STAGE 2 ROAD SAFETY AUDIT

Proposed Roundabout Access, Thornhill Road, South Marston, Wiltshire on Behalf of Brookbanks Ltd

Date: August 2023
Issue No. 2

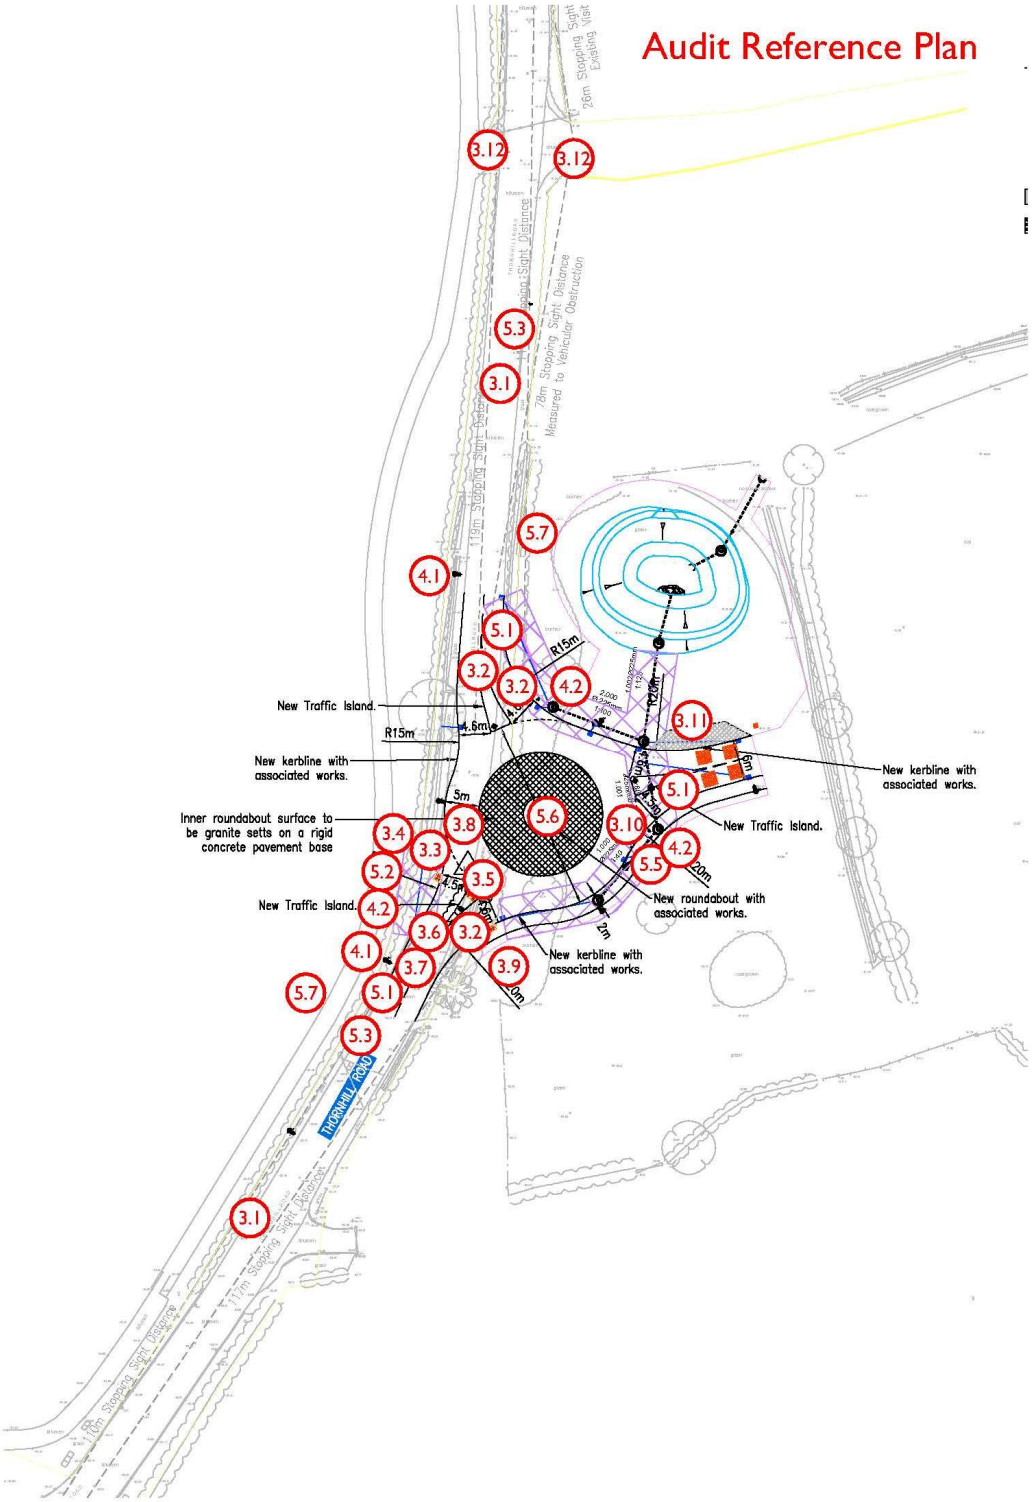
The roundabout is proposed on Thornhill Road within a section of highway that is subject to the national speed limit. Forward visibility splays have been shown on the visibility plan provided to the Audit Team. The visibility splay dimensions shown are not consistent and are below the standard for a 40mph design speed. As mentioned in section 2 above, the section of Thornhill Road considered as part of this audit is currently subject to national speed / 60mph. Collisions may occur should vehicles travel along the carriageway without adequate forward visibility of the proposed roundabout.

Swept path analysis showing various vehicles travelling through the proposed roundabout has been provided to the Audit Team. The swept path of the articulated vehicle shows that it will mount the kerb at various locations, colliding with proposed bollards and highway signage.

A pedestrian crossing point is proposed across the southern splitter island of the proposed roundabout. There is an existing shared footway / cycleway / bridleway to the west of Thornhill Road at this location. There does not appear to be a connection between the proposed crossing point and the existing route. The area between the crossing is currently grass verge with a level difference between the shared route and the existing road. Pedestrians wishing to cross Thornhill Road from the New Eastern Villages (NEV) development may have difficulty

A pedestrian crossing point is proposed across the southern splitter island of the proposed roundabout. As mentioned in Safety Concern 3.3 above, there does not appear to be a connection detailed between the proposed crossing point and the existing route. On the assumption a connection is to be provided, there is no warning tactile paving detailed to inform visually impaired pedestrians that they are joining a shared route and to be mindful of cyclists and horses.

A pedestrian crossing point is proposed across the southern splitter island of the proposed roundabout. As mentioned in Safety Concern 3.2 above, a shared footway / cycleway / bridleway currently lies to the west of the proposed roundabout. The facilities detailed to enable off-road travel between the shared route and the NEV development do not appear to cater for cyclists. Cyclists may however use this route rather than risk negotiating the roundabout and continue along Thornhill Road. During the site visit, all cyclists observed were using the off-road facilities rather than travelling along Thornhill Road. The footway and splitter island width are not sufficient for cycle use. Cycles may be struck when waiting on the splitter island due to insufficient available width.

A pedestrian crossing point is proposed across the southern splitter island of the proposed roundabout. Pedestrian visibility splays have not been detailed on the drawings provided to the Audit Team. Should a pedestrian step into the carriageway with insufficient warning of approaching vehicles they may be struck.

A pedestrian crossing point is proposed across the southern splitter island of the proposed roundabout. The proposed refuge width would appear to be 1.5-1.6m in width. This is below the current preferred width for pedestrian refuges. Given the safety concern raised in paragraph 3.1 above, pedestrians may be struck by passing vehicles while waiting in this refuge.

No entry path curvature details for the various arms of the proposed roundabout have been provided to the Audit Team. The south-to-north movement does not appear to have much deflection despite the 'step' in carriageway alignment that has been shown. Vehicles approaching the roundabout may be encouraged to do so at an excessive speed and not slow down / react accordingly to traffic within the roundabout, colliding with said traffic; or kerbs / street furniture in an attempt to avoid vehicle-to-vehicle collision.

The proposed roundabout is to be located to the north of an existing residential property. This property has a vehicle access that will be located some 10-15m to the south of this proposed roundabout. Due to the location and alignment of the roundabout, coupled with vegetative growth in both the public highway and the residential property, vehicles egressing the residential property may not have sufficient visibility to approaching traffic; particularly traffic approaching from the NEV development that may be travelling faster than traffic from the north due to the entry path curvature of the eastern arm of the roundabout. Collisions may occur should vehicles enter the carriageway without adequate visibility of approaching vehicles.

As mentioned in Safety Concern 3.8 above, no entry path curvature details for the various arms of the proposed roundabout have been provided to the Audit Team. The east-to-south movement appears to have an overly generous radius. Vehicles travelling through the roundabout in this direction may do so at high speed. This higher approach speed may exacerbate the issue raised in Safety Concern 3.9 above.

A maintenance bay had been detailed on the north side of the roundabout between the northern and eastern arms. Maintenance vehicles will typically not have rear windows for drivers to see through. As such, drivers leaving this bay in the orientation shown may not have adequate visibility of approaching vehicles, particularly those approaching from the north. Maintenance vehicles may enter into the path of circulating vehicles, resulting in a collision.

A proposed lighting plan has been provided to the Audit Team indicating the location of a number of proposed street lighting columns. This plan details lighting columns to be located within the existing vegetation. This vegetation may obscure the light spread of the columns, reducing their effectiveness, posing as a risk that drivers may have insufficient illumination of the roundabout junction. The positioning of the columns may also cause issues with access to the columns for maintenance.

A proposed lighting plan has been provided to the Audit Team, as well as a traffic signs and road markings plan. Lighting for the proposed signs has not been indicated on either of these plans. The effectiveness of all proposed signs may be reduced due to the relative locations of the proposed street light columns.

The approach lanes to the roundabout appear to be intended as single lane, however, the entry widths are sufficient for two cars. There may be differing opinions of approaching drivers where some may treat it as single entry and others may feel it is wide enough for two; with the drivers believing it is single lane entry taking a straighter "driver's line" through the roundabout potentially colliding with vehicles that believe there is room for two.

A pedestrian crossing point is proposed across the southern splitter island of the proposed roundabout. As mentioned in Safety Concern 3.3 above, there does not appear to be a connection detailed between the proposed crossing point and the existing shared route on the western side of Thornhill Road. On the assumption that a connection is to be provided, there is no signage detailed to inform pedestrians that they are joining a shared route and to be mindful of cyclists and horses.

Thornhill Road currently has intermittent kerb lines in the vicinity of the proposed roundabout and as such, edge of carriageway road markings are in place to assist drivers travelling along this road. It is unclear from the drawings provided to the Audit Team if kerbing is to be installed at the outer edges of the proposed roundabout. Drivers may have difficulty negotiating this stretch of road and proposed junction during periods of inclement weather / low levels of light (e.g. fog) without the reflective road markings.

Signage has been detailed to be provided at the immediate approaches to the roundabout. One of these signs is detailed to be located within the proposed footway. No dimensions have been detailed of the sign's location, but given the required set back required for signage from the edge of the carriageway, it is likely that the sign post may become an obstruction to pedestrian traffic at this location; particularly push chair and wheel chair users.

Signage has not been detailed on the roundabout to indicate a sharp deviation of route (Diag 515 or similar) or to keep left (Diag 610). Drivers approaching the roundabout from all arms may be unaware that they might find it difficult to negotiate the entry to the roundabout without slowing down as the severity of which cannot easily be seen either by day or by night.

No details of the proposed speed limit through the NEV development have been provided to the Audit Team. No change of speed limit signage has been detailed on the drawings provided

Safety Concern Reference No	Summary of Road Safety Concern	Designer's Response
3.1	Forward visibility	Speed surveys have been taken along Thornhill Rd showing 85th percentile speeds to be below 40mph in both directions (circa 36mph). The forward visibility chosen for the design reflects this measured speed to ensure that the design is in keeping with the actual speed of the road. If the visibility splays are increased to those appropriate for 60mph it is considered that this would only encourage higher entry and exit speeds from the roundabout into a wider network that does not support those speeds.

3.2	Vehicles over-riding kerbs	It is not anticipated that a sizeable articulated HGV would have need to enter the roundabout from the north and enter the site. South Martson Village is already restricted to 7.5t limit apart from access. In addition along Old Vicarage Road from the other direction through the development HGV access would be restricted by both the bridge under the railway and the South Marston restriction to through traffic above 7.5t. For the very rare occasion a HGV may make this manoeuvre, signs and street furniture have been moved back to avoid damage, with the track being updated to show this.

3.3	No pedestrian connection between roundabout and existing path	The designer acknowledges that the current design shows a pedestrian crossing to what is a hedge and verge between it and the western footway on Thornhill Road. However the verge on which the hedge line is located is neither in the applicants or the highway authorities control and therefore the design as shown cannot complete the connection to the western footway in this submission. The Connection has been required by the Highway Authority who will seek to use their powers in the future to complete the connection.

3.4	No warning tactile paving between footpath and shared space route	As above
3.5	No cycle connection between existing shared route and proposed development site	As above

3.6	Pedestrian visibility splays not detailed	Pedestrian visibility splays have been added to visibility plan.
3.7	Narrow pedestrian refuge island	The roundabout design has been restricted through land ownership constraints The splitter island cannot be amended as the deflection and entry lanes of the roundabout will not be sufficient. We acknowledge it is below standard, but the crossing has been added on SBC request as discussed above.

3.8	Entry path curvature from south to north	Agreed - Roundabout geometry drawing and DMRB schedule to be shared.
3.9	Visibility from Priory Lodge	Visibility splay shown was to show a realistic visibility, but plan to be updated to tangent of roundabout.

3.10	Entry path curvature from east to south	Agreed - Roundabout geometry drawing and DMRB schedule to be shared.
3.11	Maintenance bay location	Vehicles used for maintenance will have full visibility to be able to see oncoming traffic and should have no issues with pulling off from the maintenance bay safely. A larger bay area could encourage pedestrian parking in the bay.

4.1	Obstructed lighting columns	Agree – Sight clearance to ensure lighting visibility unobstructed.
4.2	No signage lighting shown	Agree – Signs will not be located where they may be impacted by lighting columns.

5.1	Lane widths on approach	Whilst the entry lane could be narrowed with hatching, entry lane width of 4.5m is typical for single lane entries as per 3.14.1. of CD 116.

5.2	Signage at footpath entry to shared route	See response to 3.3.
5.3	Edge of carriageway treatment	Edge of carriageway lines not recommended on approach to a junction as per TSRGD 2016 Dia. 1012.1. HB2 kerbs are proposed at the edge of the roundabout where possible to guide drivers and make them aware of the edge of carriageway. Lighting has also been suitably designed to ensure the roundabout is sufficiently lit at all times.

5.5	Sign obstructing footway	Agree – Sign to be relocated.
5.6	No sharp deviation signage	Agree – Signs added to roundabout drawings.

5.7	Speed limit signage	Agree – Roundels are shown on SMPS S38 drawings just beyond S278 boundary line, so the change of speed limit is evidenced just not in this pack of drawings.
